P-11329-1

34012

ISSUE-2

PARTY'S NAME	GENERAL CATEGORY, DELHI MARKET
PARTY'S DRAWING No.	AS PER DRAWING
ALLOY & TEMPER	HE9 WP
DESCRIPTION	VENETAIN BLIND SECTION

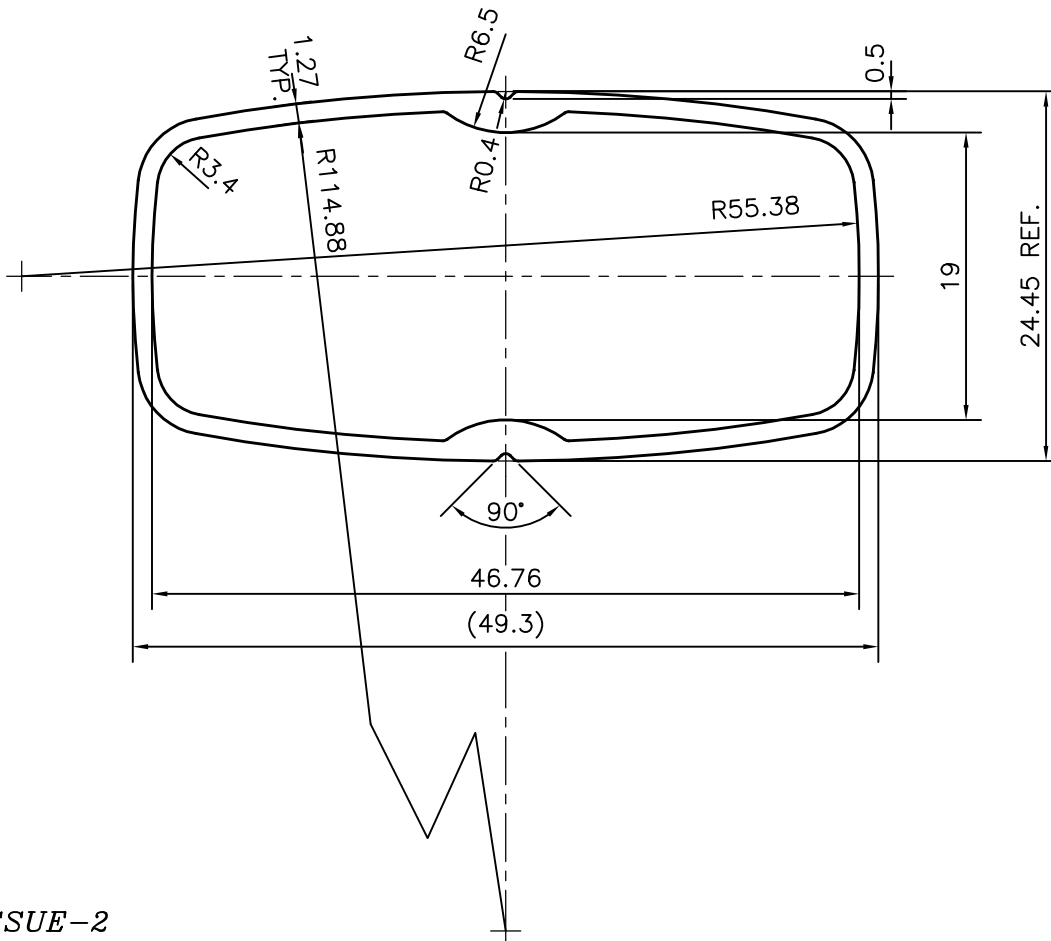
DIMENSIONS CHANGED FROM 46.5 TO 46.76, THICKNESS CHANGED FROM 1.40 TO 1.27 mm
18.5 TO 19 & RADIUS CHANGED FROM 114.75 TO 114.88, R6.75 TO R6.5

WEIGHT ALSO CHANGED FROM 0.528 Kg/M TO 0.479 Kg/M
